# Resistors Product Change Notification

<b>PCN Number</b>	PCN-2022-RBU10		
<b>PCN Title</b>	<b>Datasheet Update – LRMAP4026 Series</b>		
<b>PCN Date</b>	25 <sup>th</sup> April 2022		
<b>Type of Change</b>	<input type="checkbox"/> End of Life Notification	<input type="checkbox"/> Material Change	
	<input type="checkbox"/> Manufacturing Facility Change or Addition	<input type="checkbox"/> Process Change	
	<input checked="" type="checkbox"/> Datasheet Specification Change	<input type="checkbox"/> Design Change	
	<input type="checkbox"/> Other:		
<b>Manufacturing Location(s) Affected</b>	TT Electronics Bedlington		
<b>Date of Change Implementation</b>	25 <sup>th</sup> April 2022

**Mounting Pad Dimensions (mm)**

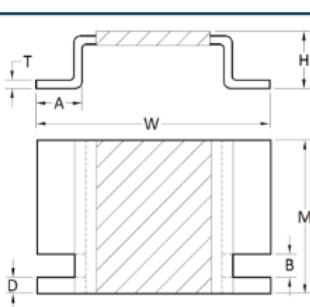
Change Detail	
<b>Description of Change</b>	Update to the LRMAP4026 series datasheet to reflect changes to the specification in terms of physical dimensions & solder pad layout. Product dimensions changed to align with industry standard for 4026.
<b>Reason for Change</b>	Physical dimensions and solder pad layout changed to bring the product in line with the Industry-standard 4026 size. See Appendix 1 for details.
<b>Implementation Plan</b>	Immediate implementation – April 2022
<b>Customer Impact</b>	None. Product post change will be compatible with both (previous and industry standard) footprint designs
<b>Recommendations</b>	Please contact your local Sales / FAE team for assistance if required.
<b>Availability of Previously Manufactured Product</b>	Please contact your local Sales / FAE team to discuss if required.
<b>Availability of Approval Samples</b>	Samples are available for approval if required. Please contact your local Sales / FAE team to discuss if required.

### Previous Oversize Product Dimensions.

Dimensions in mm and weight in g									
Value	Alloy	M +0.3	W ±0.3	H ±0.5	D ±0.1	A ±0.2	B ±0.15	T ±0.1	Wt. nom.
L20	A	6.6	10.1	3.5	0.7	2.0	1.0	0.4	0.73
L30	0.85								
L50	0.47								
L70	0.34								
1L0	0.26								
2L0	0.36								
3L0	0.22
